Delegated Report

Planning Application No: 20240998

Location: BRT Properties Kent, Top Yard, Hardys Corner, 2 Vale Road, Northfleet

Description: Application for the variation of condition 2 attached to appeal ref APP/K2230/W/22/3302467 relating to erection of a three storey building with rooms in the roof space to provide 14 x two bedroom self-contained flats, with associated access, car parking, cycle parking, refuse stores and amenity space; to allow the alteration of the design of the windows and different sized dormers and ground floor doors accessing private terraces to be altered to windows and adjust the landscaping to suit.

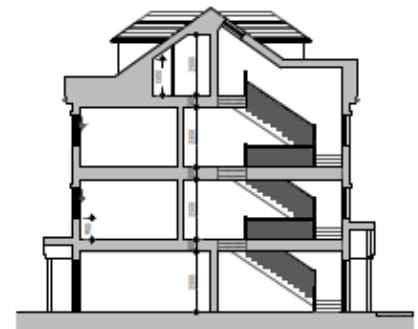
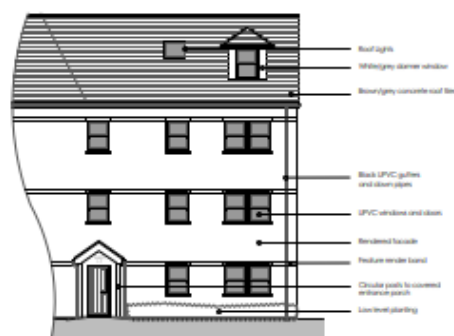
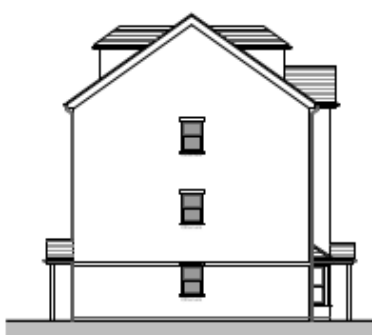
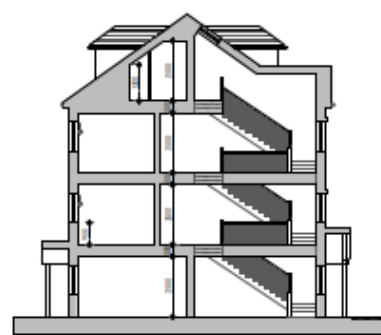
The differences are removal of dormer and ground floor window no the front (south-east facing) elevation; reduction in the number of dormer windows in the roof (their replacement with rooflights) and front elevation windows (north-east facing); reduction in dormers in the roof (their replacement with rooflights) and rear elevation windows, loss of three storey projection to the south-west and north west elevation; and a reduction in windows to the south facing rear elevation.

Low level railings are also shown in front of low level planting shown on the original plans.

the domestic scale of Vale Road. The proposed changes result in less windows and, more importantly, the loss of many of the dormer windows in the roof. These changes aid in creating a development that appears simpler in terms of design and therefore less bulky and dominant. No objection is therefore raised to the changes.
